**Application for Planning Permission for
Proposed Temporary Warehouse for Storage of Construction Materials and Associated
Filling of Land for a Period of 3 Years at Lots 1445 S.B ss.2, 1445 S.B RP, 1489, 1490, 1492
and 1494 in D.D. 76 and Adjoining Government Land, Ng Uk Tsuen, Sha Tau Kok Road,
Ma Mei Ha, Fanling, N.T.**

(Application No. A/ NE-LYT/868)

Table 1: Responses to Comments from Government Departments on Planning Application No. A/NE-LYT/868 (6 February, 2026)

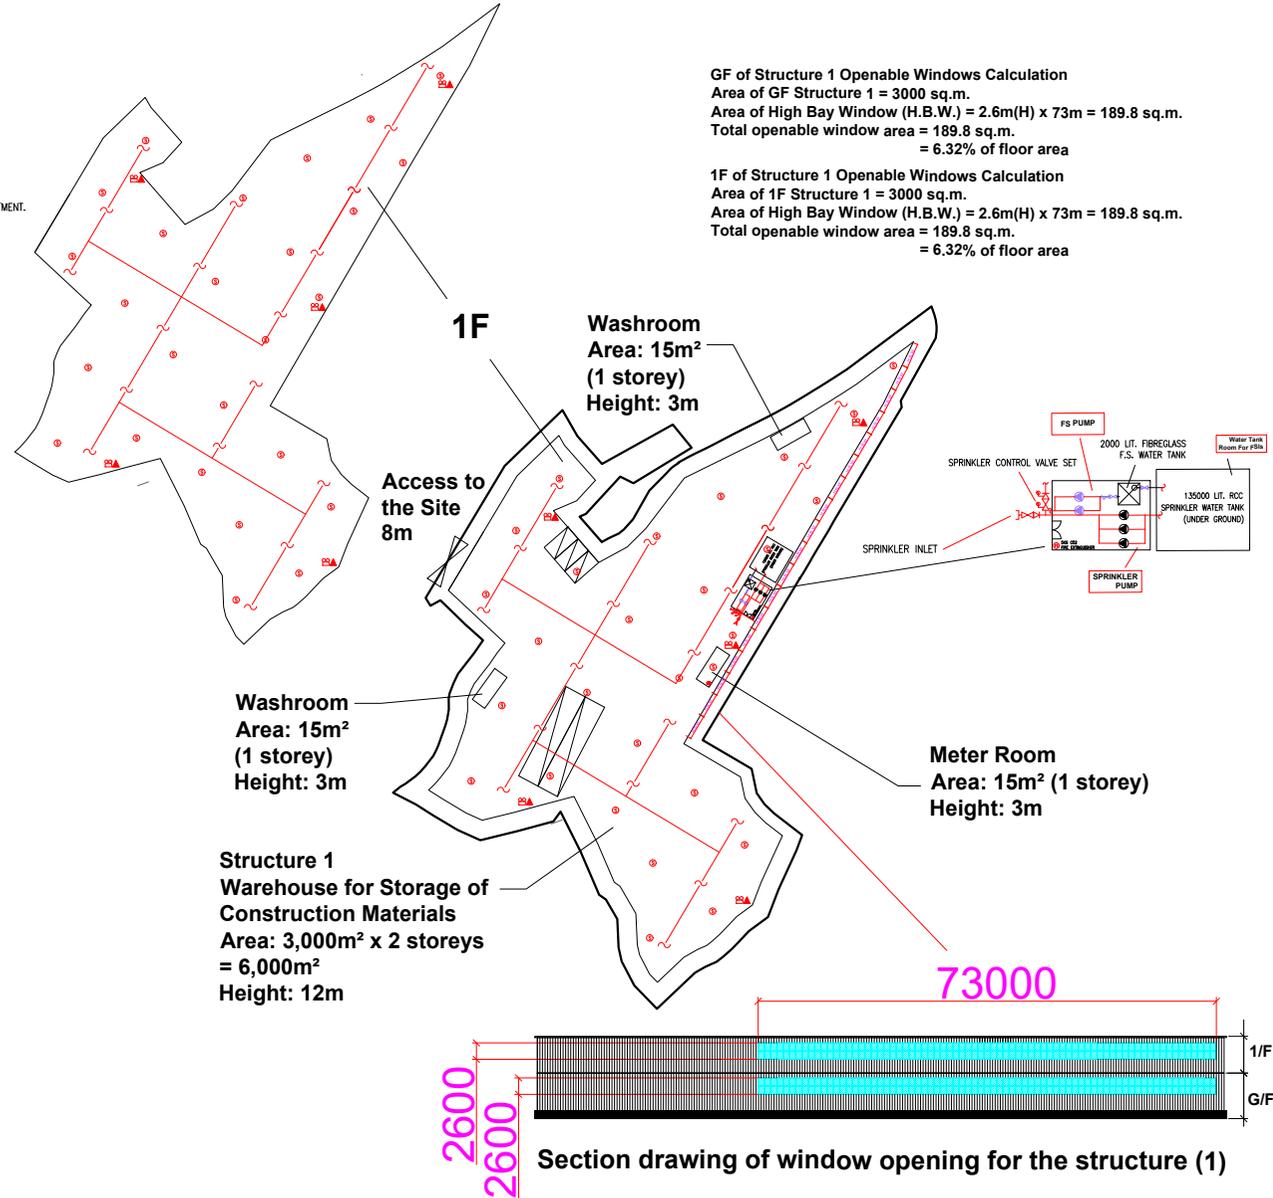
3.	Fire Services Department (Contact Person: Mr. LI Chi Fung; Tel: 2733 5844)		
(1)	In consideration of the design/nature of the proposal, fire services installations (FSIs) are anticipated to be required. Therefore, the applicants are advised to submit relevant layout plans incorporated with the proposed FSIs to his Department for approval. In addition, the applicants should also be advised as follows: a. The layout plans should be drawn to scale and depicted with dimensions and the nature of occupancy; and b. The location of the proposed FSIs to be installed should be clearly marked on the layout plans.	(1)	The fire service installations proposal (FSIs) is attached for approval (see Annex 1).

(4)	Noting that the Site is the subject of previously approved applications for similar warehouse use and there are public comments expressing concerns on the proposal from fire safety perspective, the applicants may consider to submit a FSIs proposal in support of the current application.	(4)	A FSIs proposal is attached as Annex 1 .

(3)	Public concerns on fire safety	(3)	For the previous application (No. A/NE-LYT/816), the Applicant submitted a FSIs proposal, which was approved by the Fire Services Department (FSD). Due to a change in the site layout, the Applicant is submitting a revised FSIs proposal (see Annex 1) with this application. If this application is approved, the Applicant will provide FSIs to the satisfaction of FSD.

Approved Drainage Plan under Application No. A/NE-LYT/816

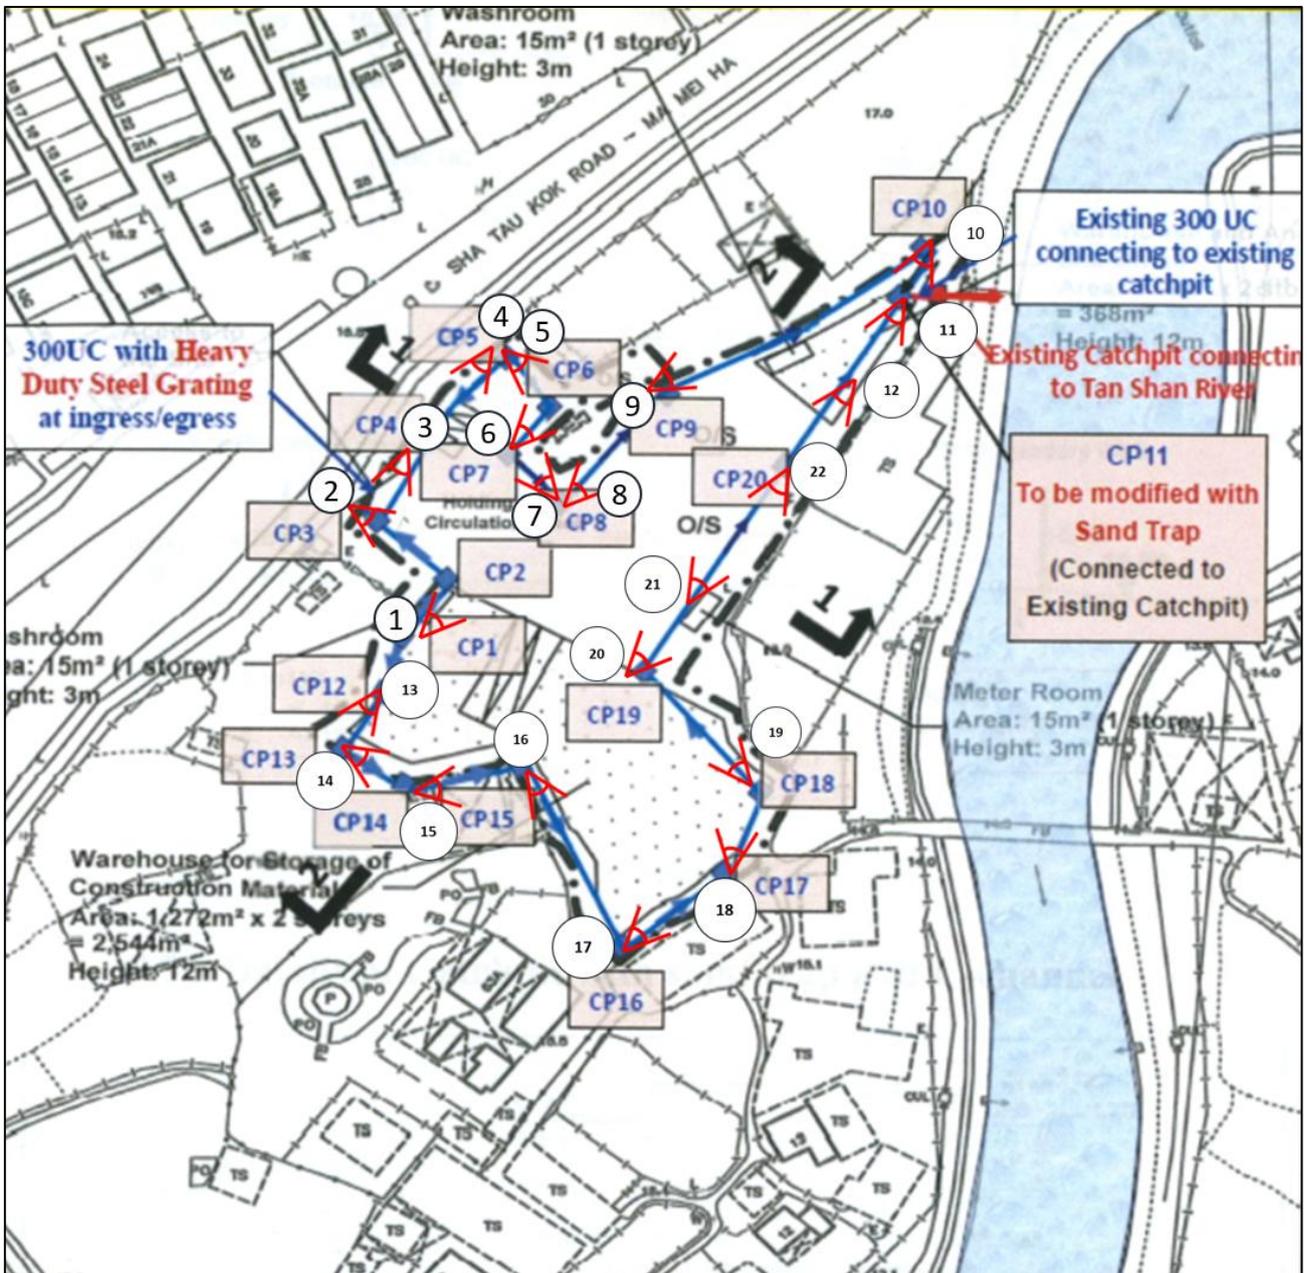
(1)	The applicants shall submit condition records of the implemented drainage facilities to demonstrate that there will be no adverse drainage impact to the adjacent area.	(1)	Photos of the condition records of the implemented drainage facilities are attached for your reference (see Annex 2).

Condition Records of the Implemented Drainage Facilities
